**SUBJECT:** Magnetic Compass Interference

**MODELS AFFECTED:** M20B 1701 thru 1851, 1853 thru 1939  
M20C 1852, 1940 thru 3286  
M20D 1, 101 thru 259  
M20E 101 thru 950

WIRING SCHEMATIC FOR SERVICE LETTER NO. 20-134

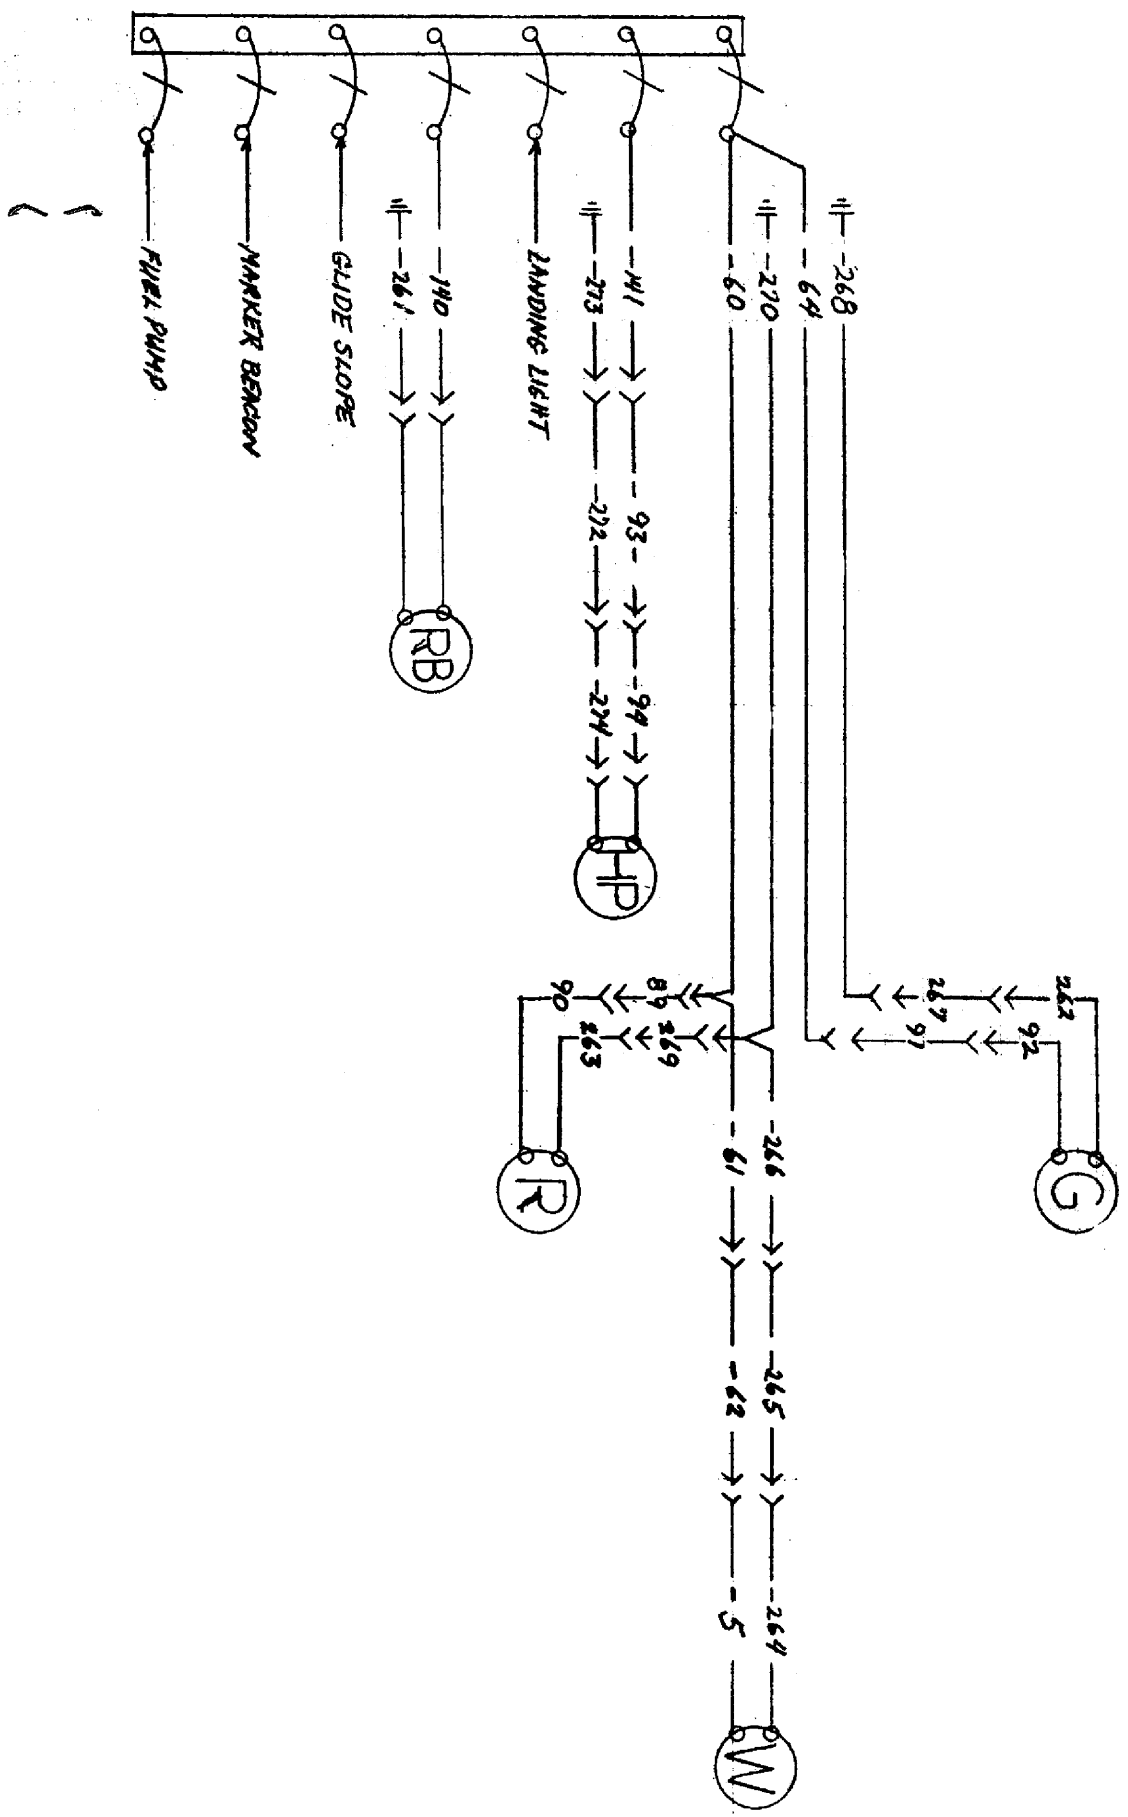
**INTRODUCTION:** The compass error induced by using the airframe as a ground return path for the navigation lights, rotating beacon, and heated pitot may be reduced by the addition of a ground wire twisted together with the supply wire in each circuit.

**INSTRUCTIONS:** Remove necessary upholstery, inspection plates, access panels and fairings to provide access to the navigation light wires. Remove all navigation light wires from switch to lights. Using the attached schematic, install SLKit 20-134-1 wiring taking care not to displace grommets from wing ribs and fuselage bulkheads when pulling in new wires. Attach wires number 60 and 64 to switch and ground wires number 268 and 270 to the nearest instrument panel mounting bolt below switch. Solder wires number 90, 92 and 5 to the center contact of their respective navigation lights and solder wires number 262, 263, and 264 to the outside shell of lights. Check operation of lights.

On aircraft having rotating beacons installed, remove wiring from switch to light and remove ground wire from beacon if installed. Install SL Kit 20-134-2 wiring. Connect wire number 140 to switch and positive terminal on beacon. Ground wire number 261 to instrument panel mounting bolt nearest switch and connect to beacon negative terminal. Check operation.

On aircraft having heated pitot installed, remove wiring from switch to pitot head. Cut off terminal from pitot ground and install knife disconnect on wire. Install Service Letter Kit 20-134-3 wires using attached schematic. Connect wire number 141 to switch and ground wire number 273 on nearest instrument panel mounting bolt. Polarity at pitot head is not critical. Check operation.
